<b><u>Technical Report</u></b>			
<b>TRIM Number:</b>	<b>PA21/930</b>	<b>Synergy Number:</b>	<b>PA21/930</b>
<b>Receipt Date:</b>	<b>23 September 2021</b>	<b>DAU Date:</b>	
<b>Address:</b>	<b>L1 &amp; 2, 865 South Western Highway, Byford</b>		
<b>Proposal:</b>	<b>Extension and Alterations including Signage</b>		
<b>Land Use:</b>	<b>'Shop'</b>	<b>Permissibility:</b>	<b>P (Permitted)</b>
<b>Owner:</b>	<b>Lenz Corp Pty Ltd Atf The Lenz Investment Trust</b>		
<b>Applicant:</b>	<b>D Forbes</b>		
<b>Zoning:</b>	<b>Urban Development</b>	<b>Density Code:</b>	<b>N/A</b>
<b>Delegation Type:</b>	<b>12.1.1</b>	<b>Officer:</b>	<b>Ryan Fleming</b>
<b>Site Inspection:</b>	<b>Yes</b>		
<b>Advertising:</b>	<b>Yes</b>		
<b>Outstanding Internal Referrals:</b>	<b>No</b>		
<b>External Referrals:</b>	<b>No</b>		
<b>Within a Bushfire Prone Area:</b>	<b>No</b>		
Part 10A, Cl. 78B of the Planning and Development (Local Planning Schemes) Regulations 2015 exempts the requirement for a BAL assessment.

The purpose of this assessment is for Council to consider a development application for alterations, additions and signed to the existing retail development at Lot 1 and Lot 2, 865 South Western Highway, Byford

**Figure 7: George Street (West) frontage showing the screening frame to the right and new loading dock to the left**

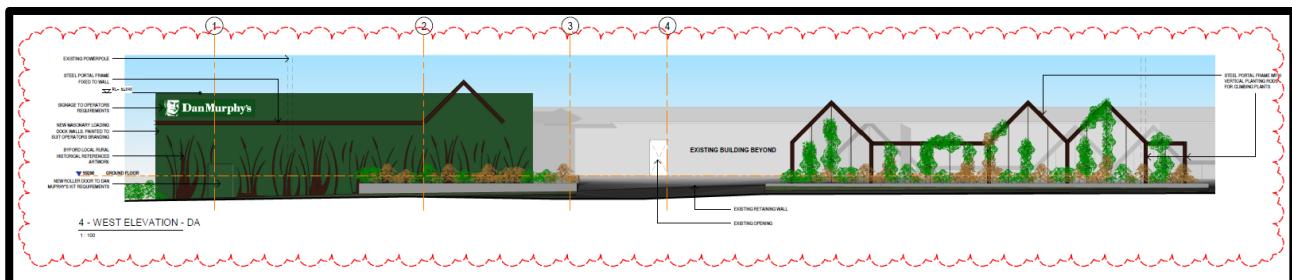
Policy Objectives	Policy Requirement	Proposal	Officer comment
promote energy efficient design principles	This may include but is not limited to:		proposes a 6.18m high and 22m in length flat building façade to George Street, with visual interest to be approached through public art treatment and a lightweight portal section on this wall.
O5.4. Utilise building articulation elements of appropriate scale to their use and context	<ul style="list-style-type: none"> <li>• Projections and/or recessions;</li> <li>• Balconies, roof gardens and verandahs;</li> <li>• Tower elements on corner sites where solar access is considered;</li> <li>• Shade devices, noise barriers and privacy screens;</li> <li>• Expression of building entries with awnings, porticos, recesses, blade walls and projecting bays;</li> <li>• Deep window reveals; and</li> <li>• Interesting roof forms and varied colours and materials.</li> </ul>		The proposed loading dock wall will be a prominent structure on what is to be a key street within the Byford Town Centre Train Station precinct. Officers note the policy framework that strives for a positive design outcome in this regard, and that the public art condition for this wall aims to address this.

Ensure landscape design does not conceal the views of paths and open spaces from streets and surrounding developments.	The landscaping will be small scrubs. The planting frame will be visually permeable, softening the back of house visuals of the development, while also not blocking full view or create concealable spaces.	Compliant.

As detailed above, the Shire policy expectation to enhance the interest of the building and to engage pedestrians within the public domain is for elevations of the development to be used for public art. As such, the recommendation includes conditions of approval for the provision of public art. This will ensure general consistency with the overall planning framework for the site.

**Figure 8: IGA sign on existing pylon sign to be replaced with 'Dan Murphy's' signage**

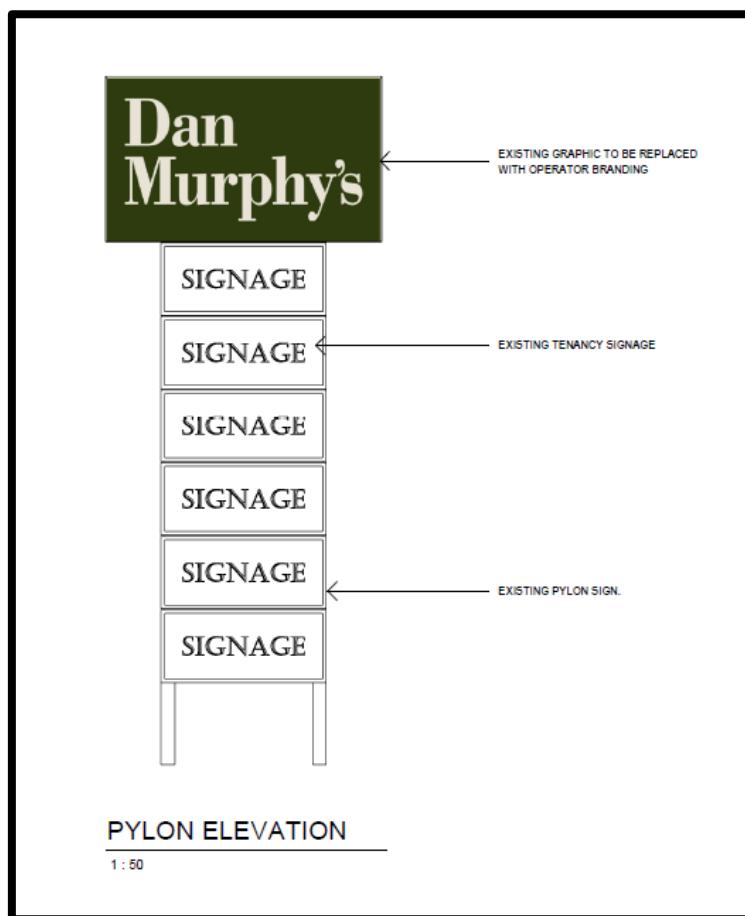
<b>LPP4.11 – Advertising Assessment</b>		
<b>Provision</b>	<b>Proposal</b>	<b>Officer comment</b>
<b>Pylon Sign</b>		
The maximum sign face area is 10m <sup>2</sup> per face, for a maximum of two faces.	No change to the existing pylon sign. Only changing the content of the sign from IGA to the new tenant's name.	N/A
The maximum height above the ground is to be 6.5m or the height of a building in close proximity, whichever is the greater, but is not to exceed 10m. The height of a building is defined as the height of the uppermost part of the building above ground level.		
Must be mounted as a free-standing structure.		
Must not be located less than 1.5m from the front property boundary (including the primary and secondary street frontages of a corner lot), and must not project beyond the alignment of any property boundary.
